Access Compliance Report Public Rights-of-Way (Curb Ramps)

Main Street: HYDRANGEA_ST		Cross Street: SKLAR_ST		Location:	NE
ADA ID: RPRK211103130446	Ramp Type: Type 4 - Parallel	Initial Pass/Fail: Fail	Overall Compliance: No	Severity Score:	30
Codes/Mitigation Info/Possible Solution			Field Measurements/Component Compliance

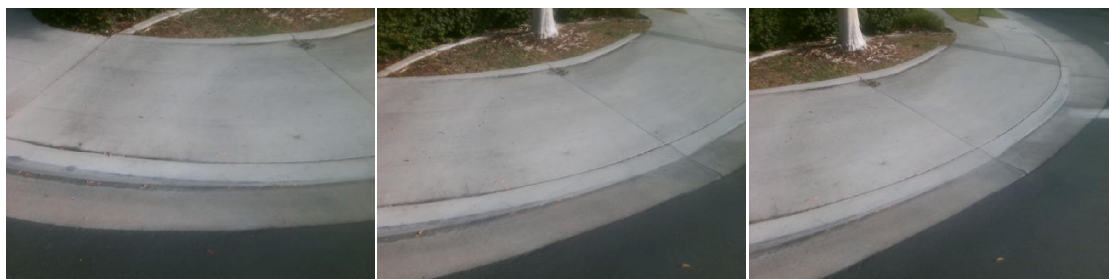
R204.3, R304.5.3, STD 1115

Remove & Replace Curb Ramp With Two New Directional Ramps or Equivalent.
